ADDENDUM No. 5 – April 3, 2026

PART 2 – SPECIFICATIONS

1. SECTION 08 87 00 – ARCHITECTURAL WINDOW FILMS

PART 3 – DRAWINGS

1. City of Worcester Department of Public Works and Parks, Engineering Division, Standard Fencing Details

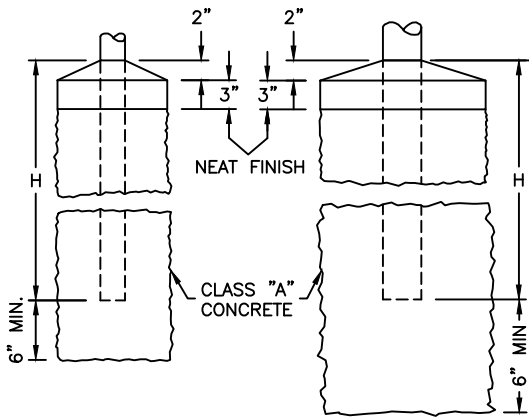
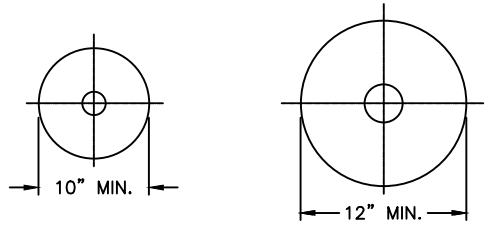
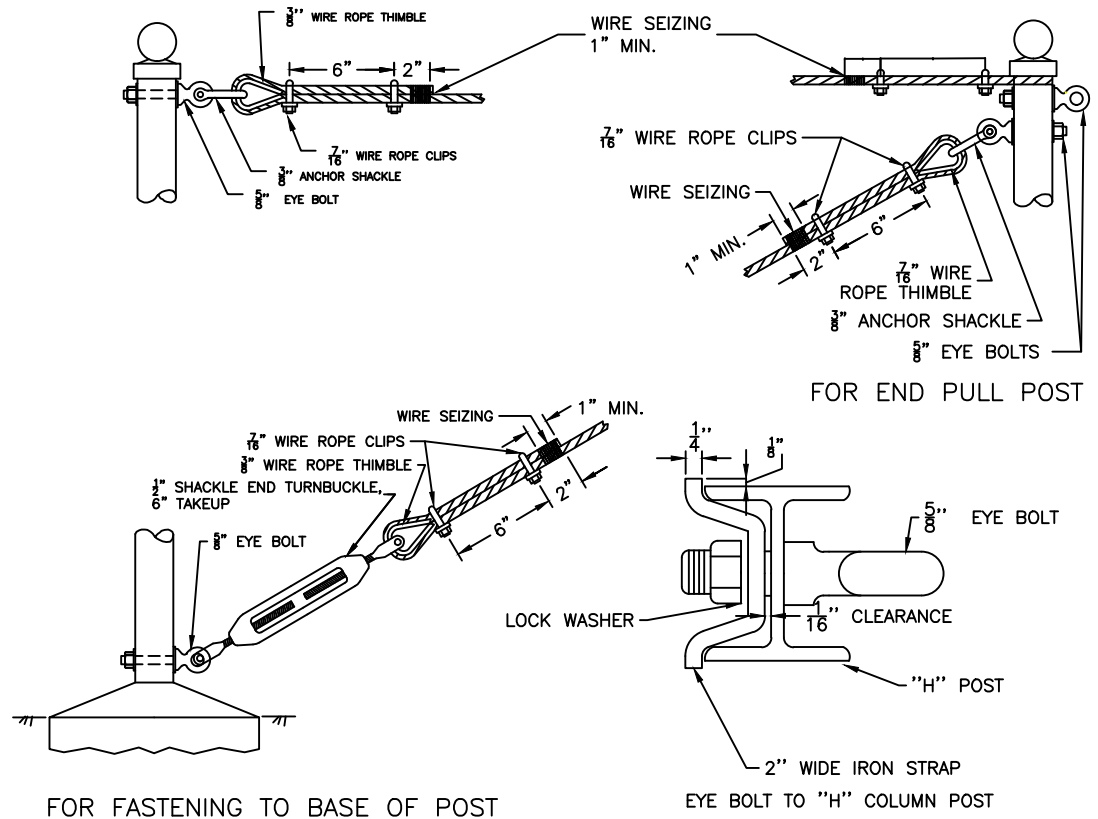
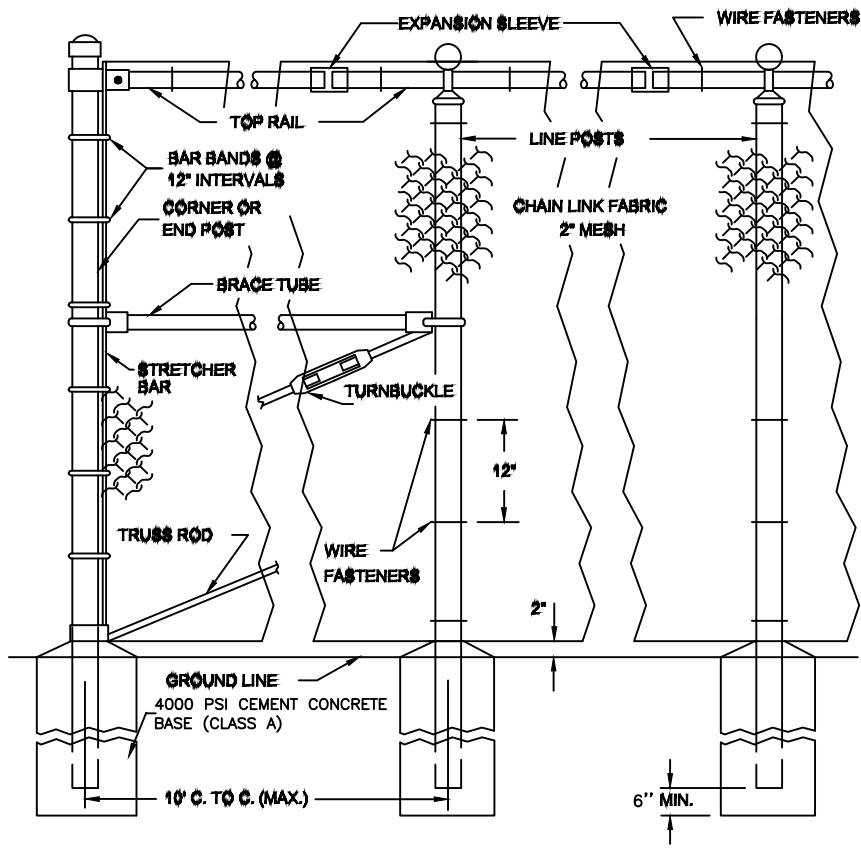
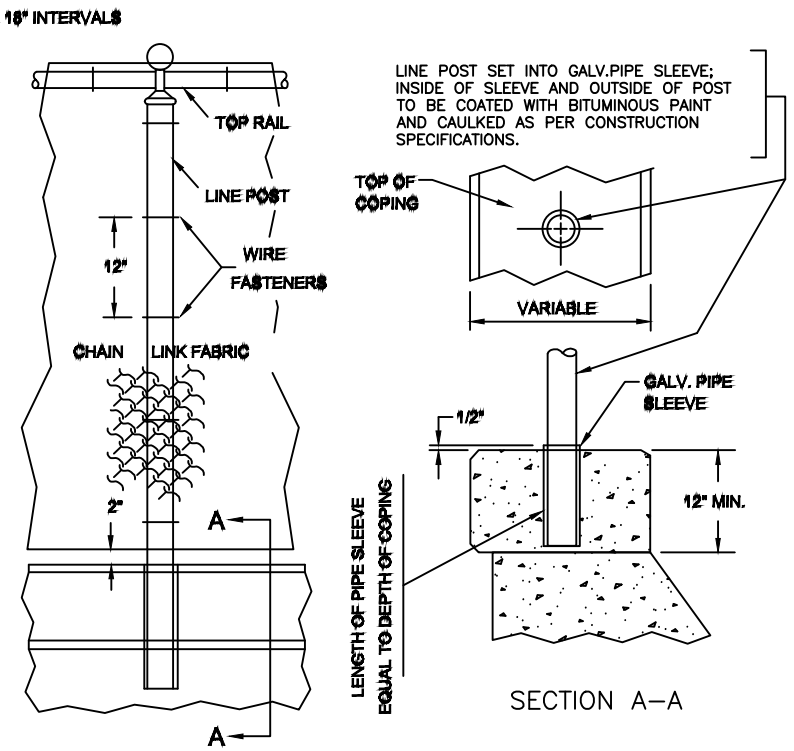
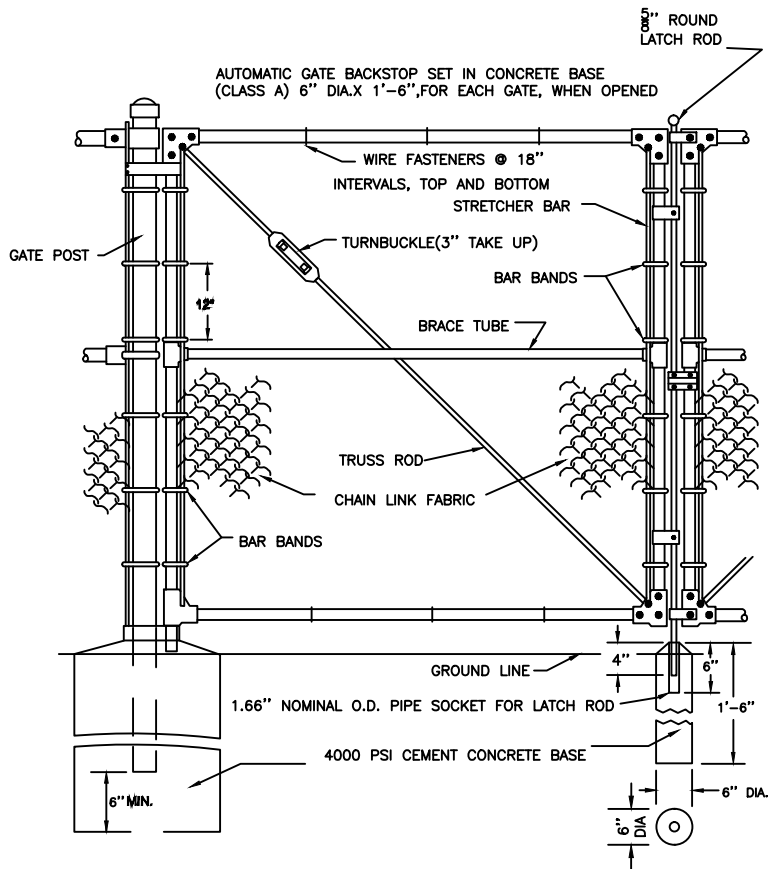
Insert: “3. City of Worcester Department of Public Works and Parks, Engineering Division, Section 644 Chain Link Fence and Gates” (attached)
